City of Chattanooga
DEPARTMENT OF PUBLIC WORKS
DEVELOPMENT RESOURCE CENTER
ENGINEERING DIVISION
1250 MARKET STREET, SUITE 2100
Chattanooga, Tennessee 37402-2713

March 3, 2014

**Re: Written Warning
NPDES/Stormwater Compliance Inspection
NPDES TMSP#TNR051467**

Fig 5. Used oil containers- No secondary containment

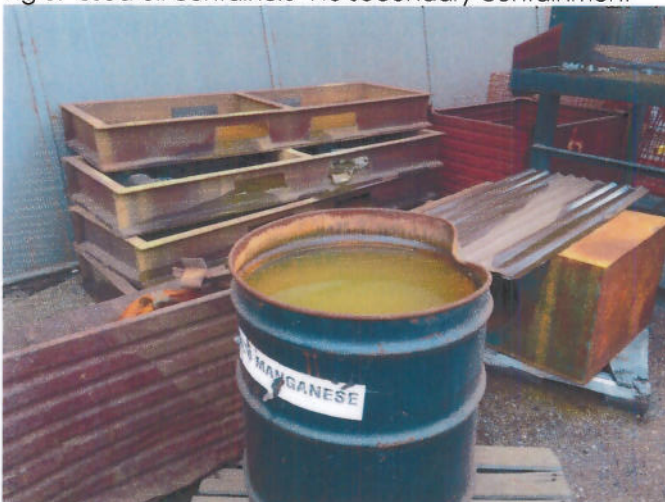
- Drums and other liquid container are not being stored properly. One was observed collecting stormwater runoff.
- General housekeeping around the facility needs some improvement. The pavement in several areas around the baghouse collectors were found with excessive accumulation of dust.
- Hazardous Waste collection vessel has a defective covering mechanism to prevent contact with stormwater runoff.
- Two used oil collection vessels must have some form of secondary containment.

- **Within 30 days** from receiving this letter:
 - Develop a **Corrective Action Plan** that will address the issues mentioned in this Written Warning letter. The plan shall be submitted to this office within 30 days of receiving this letter.
 - Implement a dredging schedule on retention pond and surrounding drainage conveyances to prevent excessive accumulation of the foundry sand.
